Subject: License Amendment Request LG 01-00909  
Extended Use of Pressure-Temperature Limits and Deferral  
of Withdrawal of Vessel Surveillance Specimens

Limerick Generating Station, Unit 1  
Facility Operating License No. NPF-39  
NRC Docket No. 50-352

**Attachment A**  
**Request for License Amendment for Pressure-Temperature Limits**  
**and Deferral of Withdrawal of Vessel Surveillance Specimens**  
**Limerick Generating Station, Unit 1**

**Marked Up Pages**

MINIMUM REACTOR VESSEL METAL TEMPERATURE VS. REACTOR VESSEL PRESSURE  
FIGURE 3.4.6.1-1

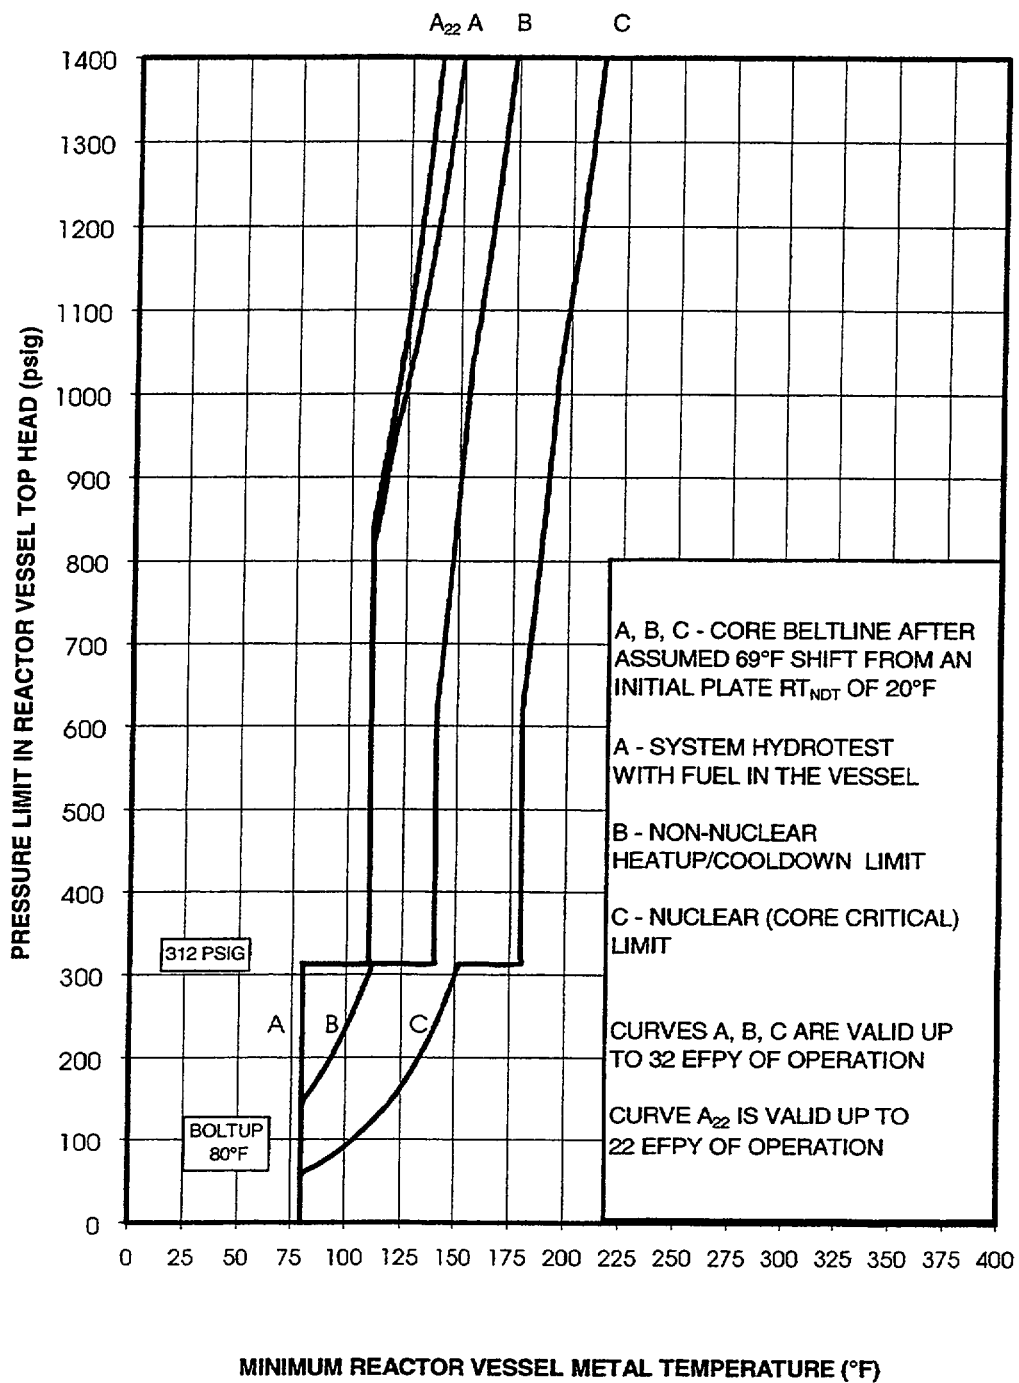
Because the GE LTR methodology is currently being reviewed by the NRC, EGC requests that the LGS Unit 1 TS Figure 3.4.6.1-1 note be modified to allow use of the current P-T limits through Cycle 10 of operation, currently scheduled to end in April 2004.

The LGS Unit 1 TS Figure 3.4.6.1-1 is proposed to read, "In accordance with NRC Safety Evaluation supporting Amendment No. \_\_\_, this Figure is valid through Cycle 10 operation, currently scheduled to end in April 2004."

Note: In accordance with NRC Safety Evaluation supporting Amendment No. 45, this figure is valid through Cycle 8 Operation, currently scheduled to end in April 2007. 14 10

MINIMUM REACTOR VESSEL METAL TEMPERATURE VS. REACTOR VESSEL PRESSURE  
FIGURE 3.4.6.1-1

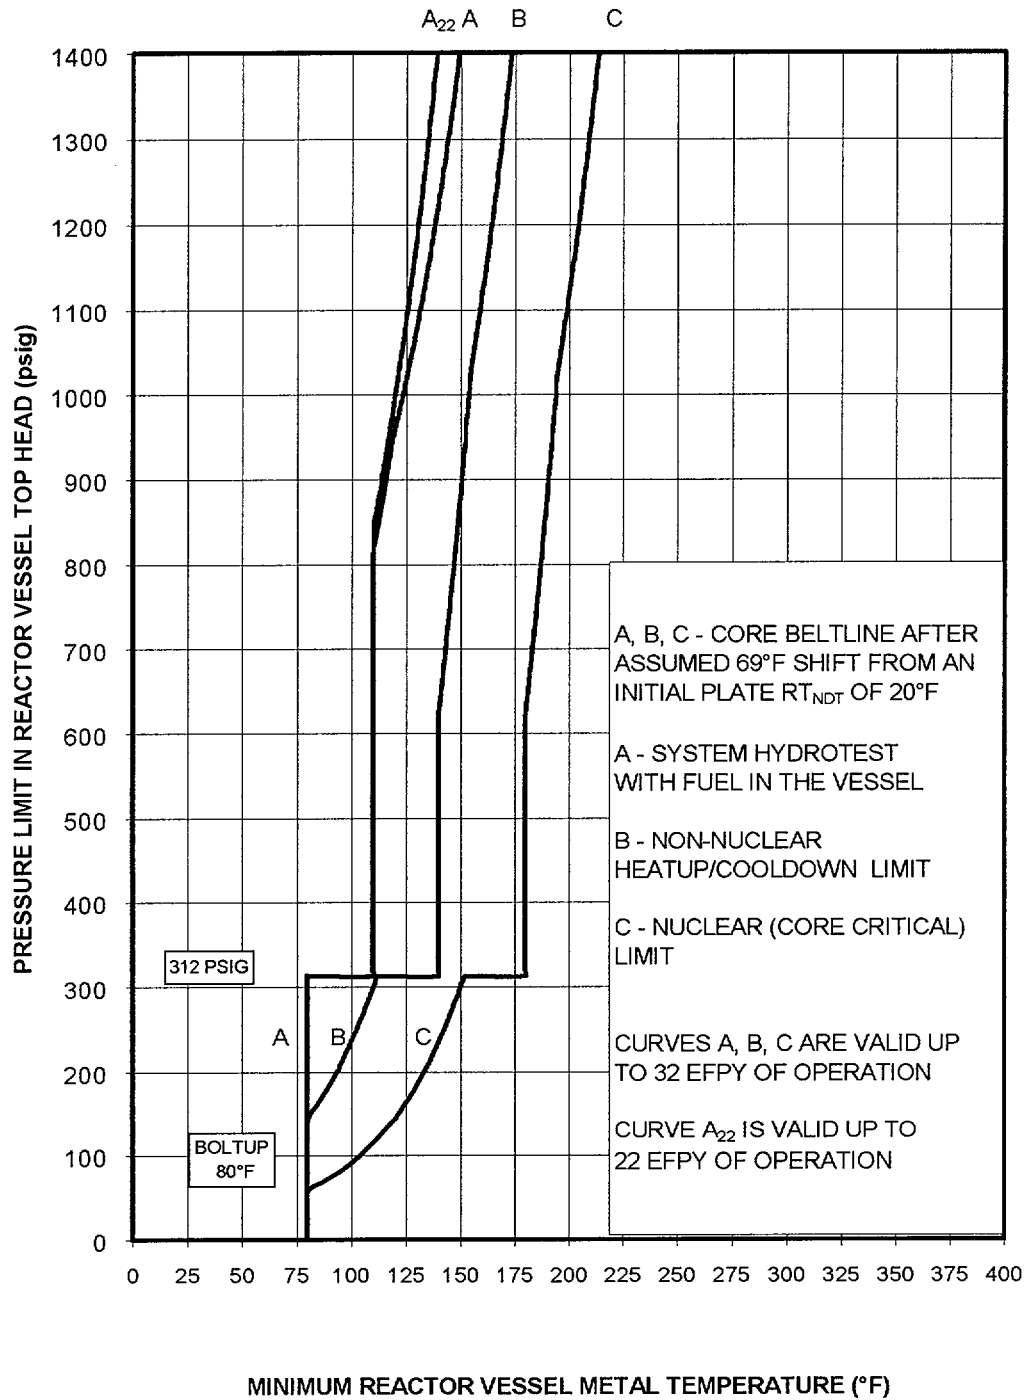
Note: In accordance with NRC Safety Evaluation supporting Amendment No. \_\_\_\_\_, this Figure is valid through Cycle 10 Operation, currently scheduled to end in April 2004.
